Corrigendum to EN 50388:2012

Corrigendum to EN 50388:2012 published 2012-08-24

## 1 Modification to Figure 1

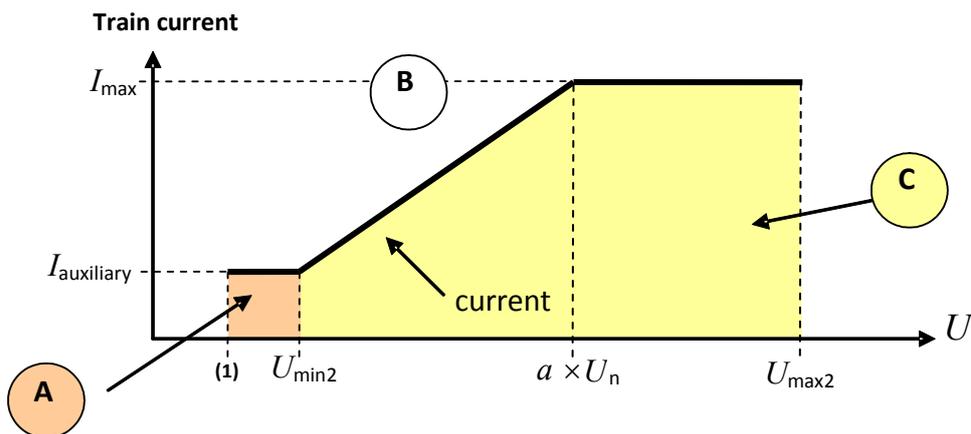
Replace Figure 1 by the following new figure:

- A** No traction
- B** Current level exceeded
- C** Allowable current levels
